SERVICE BULLETIN CHANGE NOTICE

S.B. No. A320-21-1099 REV. 01

<u>TITLE</u>: AIR CONDITIONING - AVIONICS EQUIPMENT VENTILATION - RELOCATE

SKIN TEMPERATURE SENSOR (RETROFIT SCHEME).

Drilling of the Air Inlet Valve Figure 4, Sheet 1

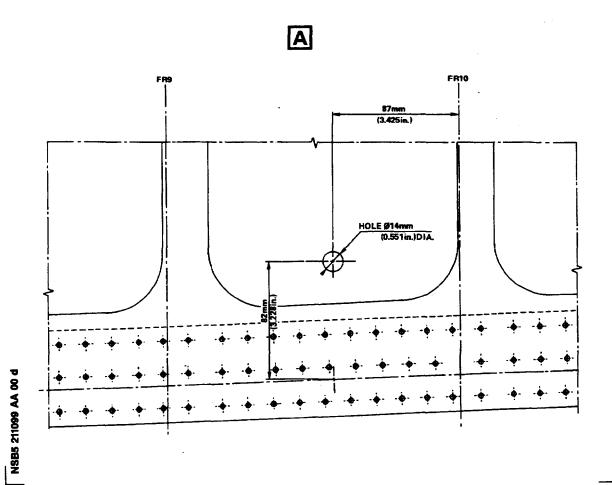
- (b) Drill one hole in the duct and in the collar as shown on view C (Refer to Figure 4).
- (c) Re-identify the duct assy Item 7:

D53912686000 or D53912686001 or D53912686002 becomes D53916795000.

Drilling of the Lateral Panel Figure 1, Sheet 1

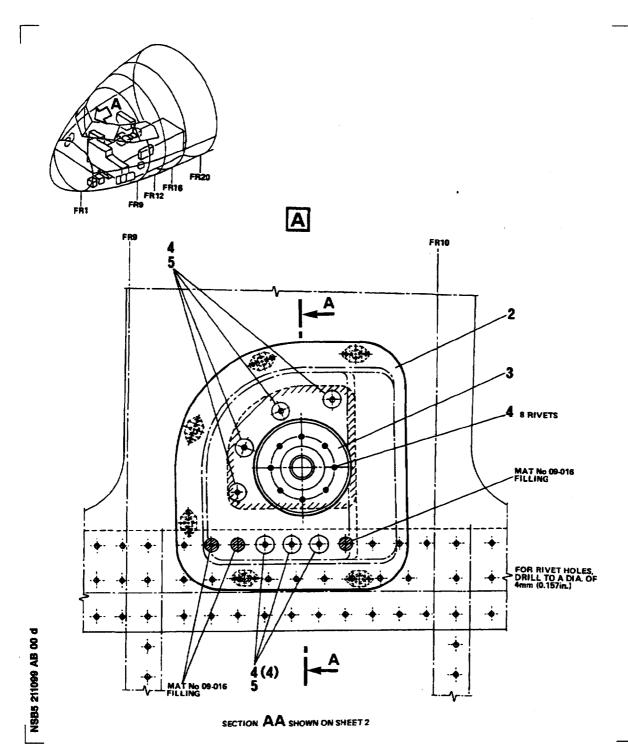
- (d) Drill one hole in the panel between frames 9 and 10 (Refer to Figure 1).
- (e) Install the lower half-box and the flange

Installation of the Half-Box and Flange Figure 2, Sheet 1

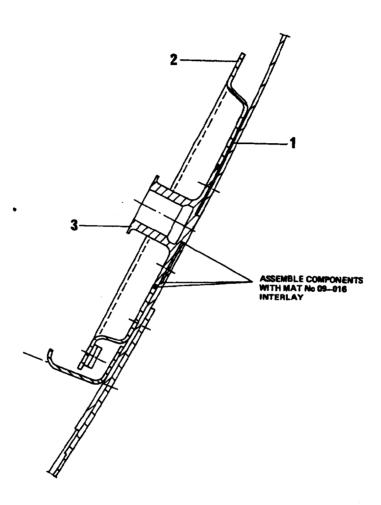
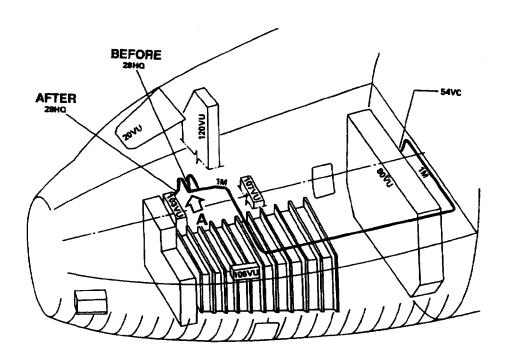
Refer to Figure 2

1 Drill out:

3 Rivets Item (4)

- 2 Put the half-box in position.
- 3 Matchdrill the rivet holes and deburr.
- 4 Install:

1 Half-Box D5391679600200 Item 2 1 Shim D5311143820000 Item 1

7 Rivets ASNA2051DEJ4020 Item 4 7 Washers ASNA0113-40CA Item 5

Modification of the Wire Routing Figure 3, Sheet 1

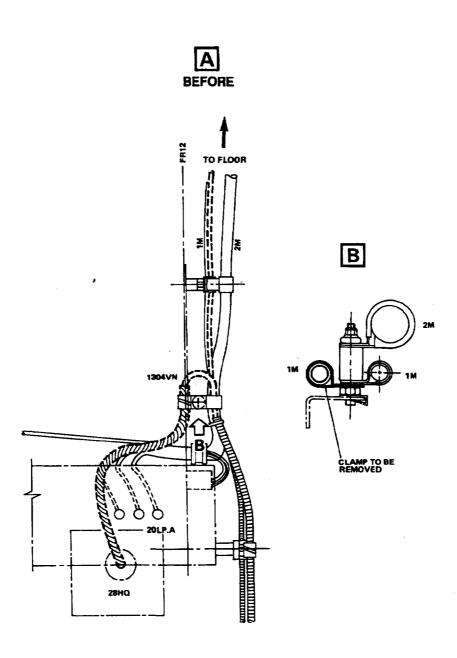
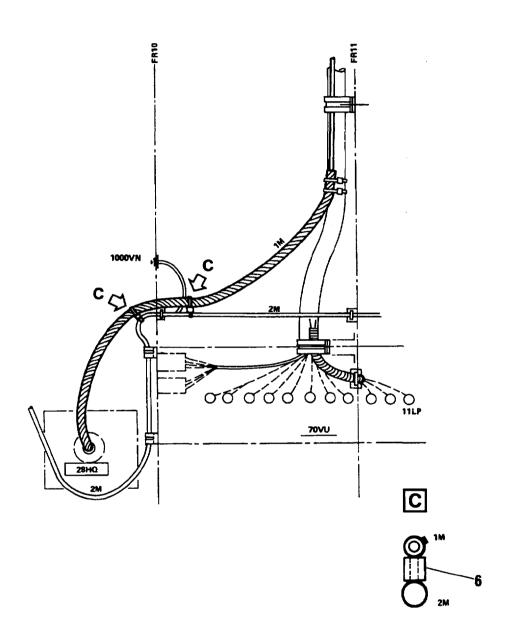
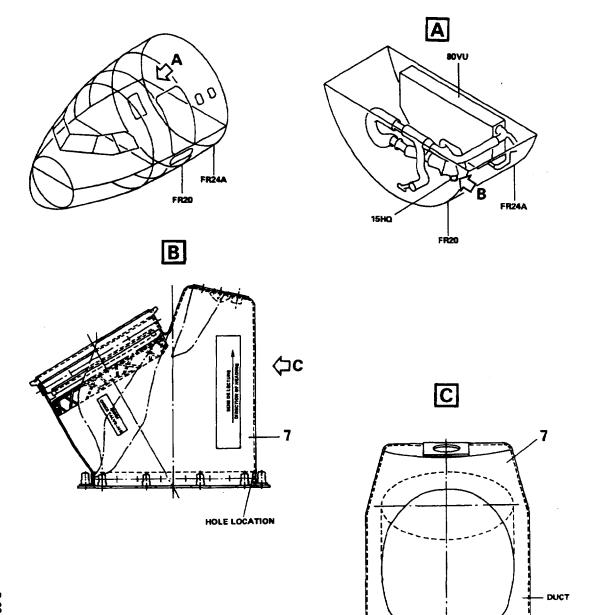
- 3 At the end of the wires connected to 28HQ, install:
 Conduit E0432A04 (Refer to Figure 3, Sheet No. 3).
- Qut the wires to the necessary length, crimp the terminals and connect them.

Refer to Figure 3, Sheet No. 3

2 Spacers NSA5527-03-01

2 Ties-Cable NSA935401-04
